## Hiawatha Corridor LRT Yards and Shops Mitigation Study

Current Concept  
Elevations  
Yards & Shops

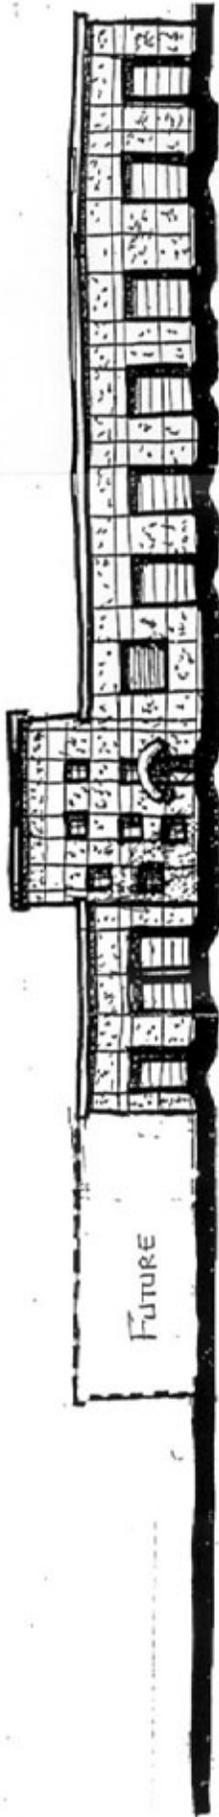
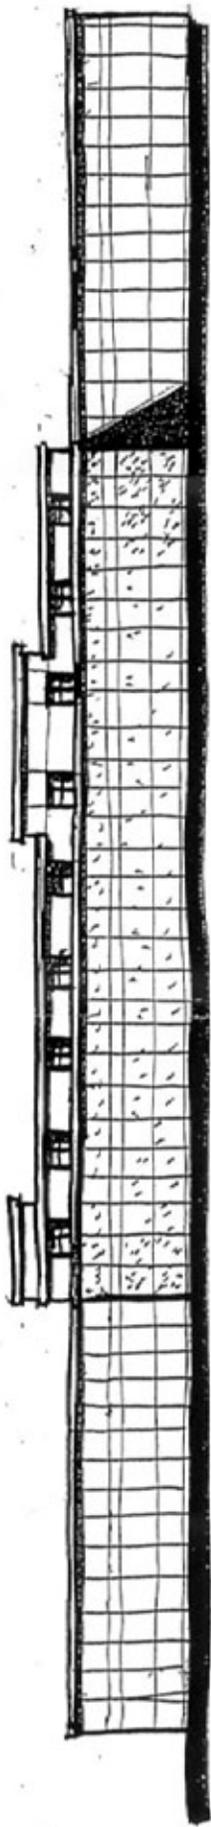
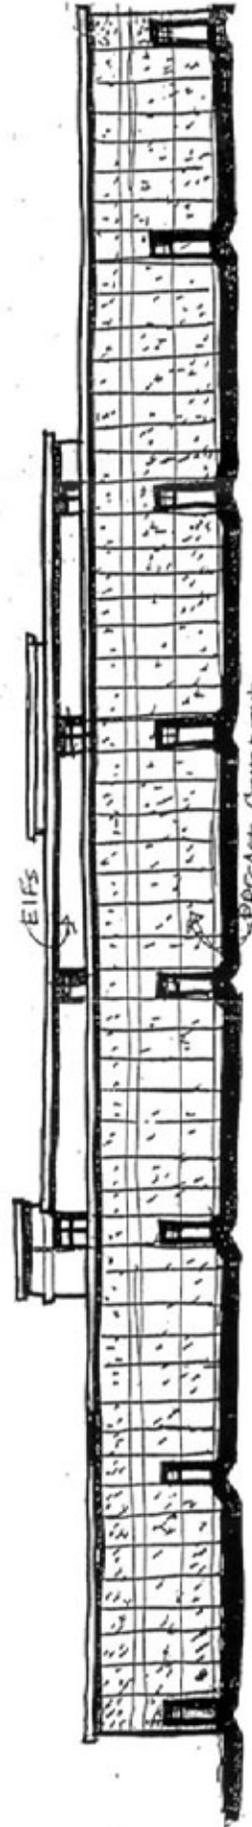
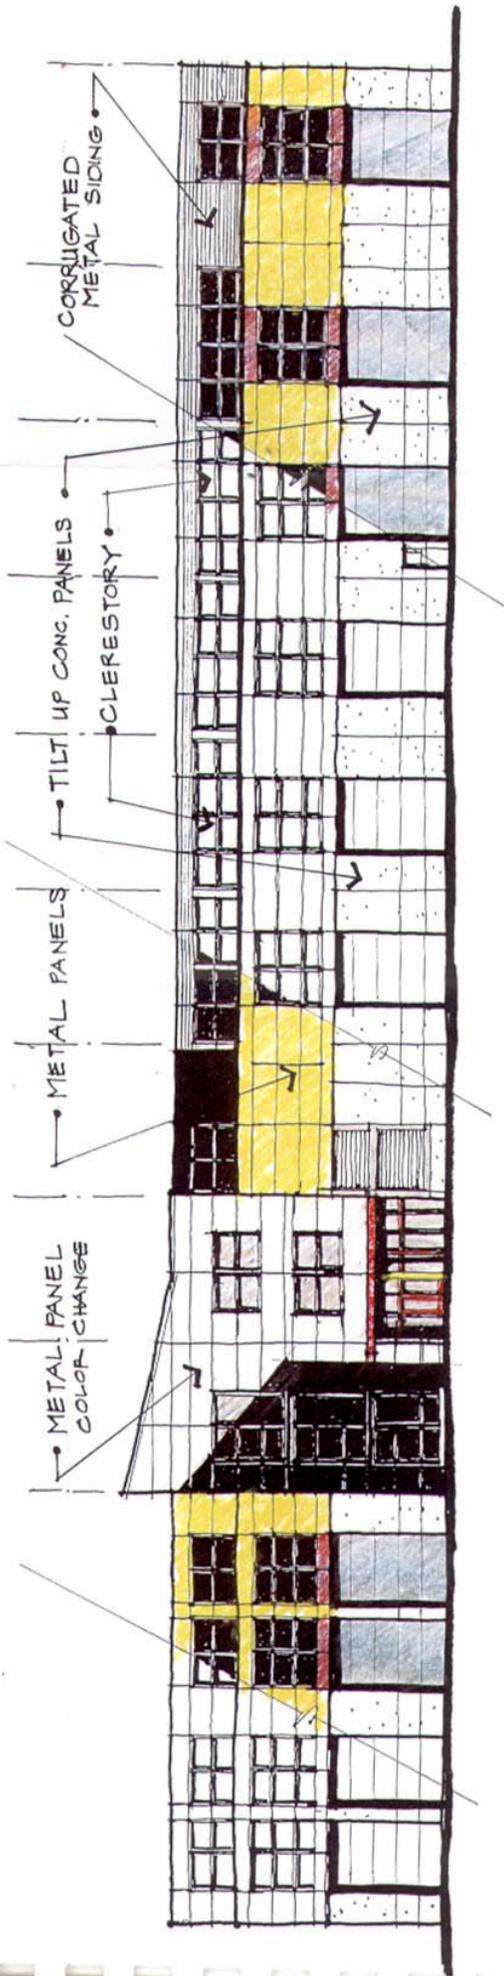
While all the facades of the building require additional design attention, priorities can be established based on the exposures and relationship to the neighborhood. The east elevation is most important since it will face the future development sites, and the existing immediate neighborhood. The long wall needs articulation. In addition to a mix of construction materials, consider planting deciduous vines that can climb the wall to add another texture and color to the wall.

The south elevation is a close second priority because it is the 'front door' of the facility and is the facade that is presented to the Franklin Avenue development sites and the transit station. This elevation offers a number of possibilities because of the overhead doors, openings, and the office functions.

The west elevation is important because it faces Hiawatha Avenue. It will be viewed mainly from vehicles at highway speeds but it is 640 feet long; approximately two city blocks. Landscape berming and tree planting will help mitigate the impact of this long unbroken wall. Deciduous vines should be planted at the base of this wall and wires attached to the wall to allow the vines to climb the wall for added texture and interest.

ELEVATION STUDY - SOUTH ELEVATION  
1/8" = 1'-0"  
otak architects p.c.  
11.20.00.

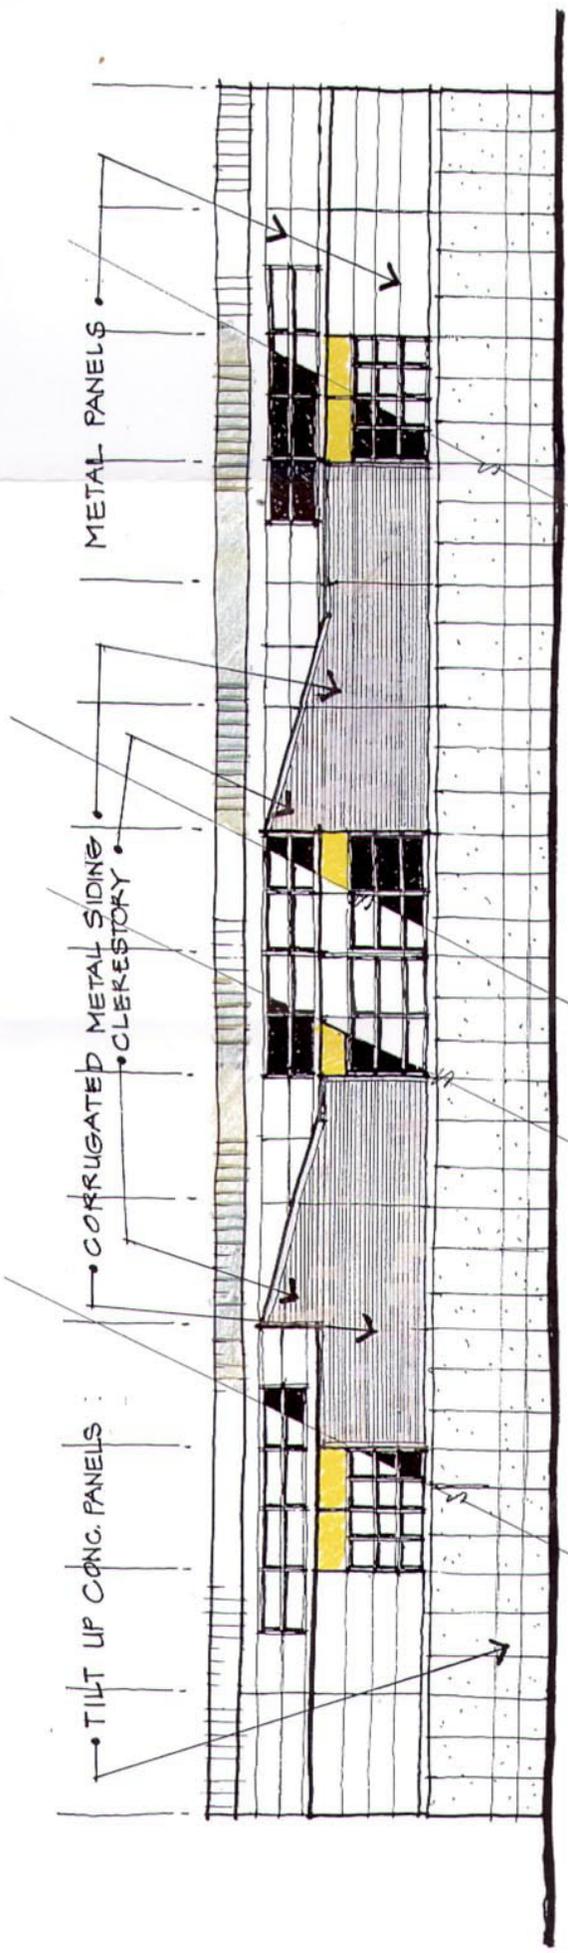
In addition to precast concrete panels, a number of interesting metal panels are available that are commonly used in maintenance facilities and normally are possible in reasonable building budgets. A sketch elevation is included that illustrates a number of the suggestions as one possible approach. Also note two examples of maintenance facilities in other cities that use simple, economical forms, materials, and color to present acceptable buildings to a neighborhood. These buildings have a long life span and will impact the neighborhood for several generations.
